ADA Curb Ramp New Construction Inspection Form (Perpendicular)

Nw 292 ave

24952.54

Nw west union rd

PERPENDICULAR RAMP (PR)

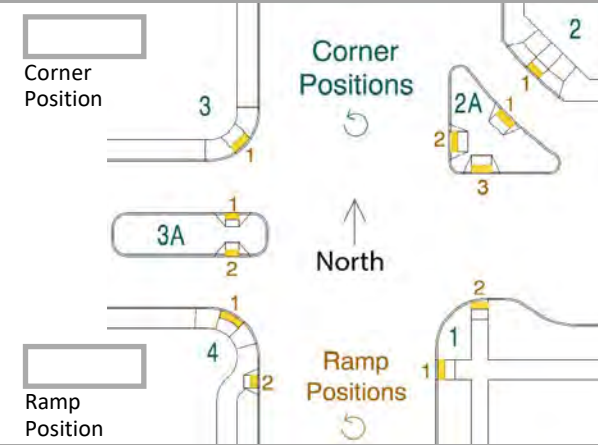
IITD not full width rr1 icrr turn space clear width less than 4'
